Brake Parachute Assemblies, Type LB 52 Mk 1 (Ref No 15D/563) and Mk 2 (Ref No 15D/645). (Hunter T7, T8, T8A, T8B, FGA9, FR10, Mk 12) - Introduction of Fork End, Part No F237558, in place of Part No F228549. Brake Parachute Assembly becomes Mk 3 (Ref No 15D/732).

(MOD No GQ/B/12)

Parachute Assembly Type LB 52 Mk 1 (Ref No 15D/563), Mk 2 (Ref No 15D/645) and Mk 3 (Ref No 15D/563) - Part A - To improve the deployment of the auxiliary parachute, Part B - To strengthen the Bridle Attachment cords. - Hunter T Mk 7, FGA Mk 9 and FR Mk 10 Aircraft.

Brake Parachute Assembly Type LB 52 Mk 1 (15D/563), Mk 2 (15D/645) and Mk 3 (15D/732) - Hunter T Mk 7, T Mk 8, T Mk 8B, T Mk 8C, FGA Mk 9, FR Mk 10.
To strengthen the main pack flap covering the strop and cable stowage.

Drg No AP 108C-0507-2

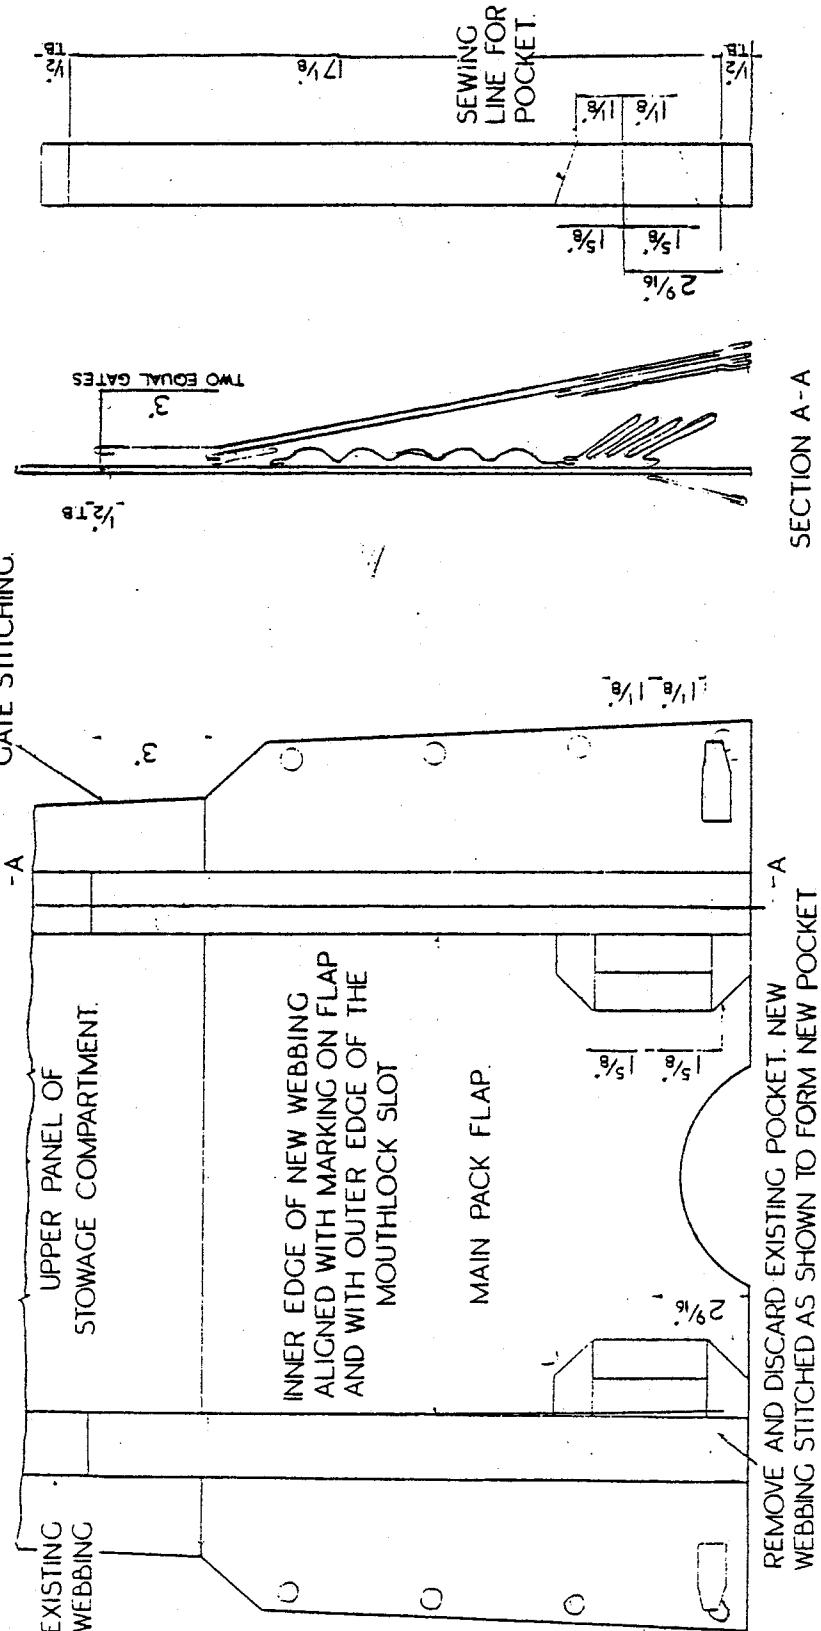
This modification is a design improvement resulting from Service experience. This experience reveals the tendency of the flap to tear adjacent to the pack mouth-lock slots, with the consequent possibility that the parachute may fail to deploy. The modification provides for the addition of two parallel lengths of webbing which will transfer loads from the mouth-locks to the main lift web.

(2) The new reinforcing webbing on the main pack flap, when attached must be in alignment with the existing webbings on the upper panel of the canopy stowage compartment. To ensure accurate alignment, prior to removal of the flap, pencil-mark two lines running down the flap from the inner edge of each existing webbing to the outer edge of each cable mouth-lock slot. Also on the flap, mark the horizontal centre-lines of both mouth-lock slots. These marks will assist in the location of the

non-stitched portion of the inner edge of each new webbing. The non-stitched portions form the cable stowage pockets on the modified flap. Refer to drawing.

For Units having to modify a large number of packs it will be time-saving to prepare handed templates, as shown on the drawing with which to mark the new webbings. With the exception of the unstitched portions of the webbings, which face inwards when attached, the template markings are identical for left- and right-hand webbings.

(4) Take two $18\frac{1}{2}$ in cut lengths of $1\frac{3}{4}$ in wide 3000 lb nylon webbing (Ref No 15D/746) and mark for left- and right-hand attachment, in accordance with the template dimensions.

(5) Form a $\frac{1}{2}$ in turnback at the lower end of the right-hand webbing and lay this end level with the bottom edge of the flap. The inner edge of the webbing is laid on the marked line running down the flap to the outer edge of the right-hand mouth-lock slot. The centre-point of the $3\frac{1}{4}$ in length from which the stitching is to be omitted is laid on the edge of the slot in alignment with the previously-marked slot centre-line. A $3\frac{1}{2}$ in free length of webbing will protrude clear of the top edge of the flap.

gate patterns of stitching covering a total length of 3 in, using heavy silk or nylon thread as above, pitched at 7 to 11 stitches per inch. Refer to drawing. Lock each gate by oversewing for a minimum of $\frac{1}{2}$ in.

When Mod No GQ/B/27 is embodied, the bights of cable are passed through the mouth-lock loops and into the pockets formed by the non-stitched portions of the flap reinforcing webbings.

SIDE SEAM TO BE
PARTLY OPENED
TO FACILITATE
GATE STITCHING.

MARKING TEMPLATE
FOR R H WEBBING.
REVERSE FOR L.H WEBBING.
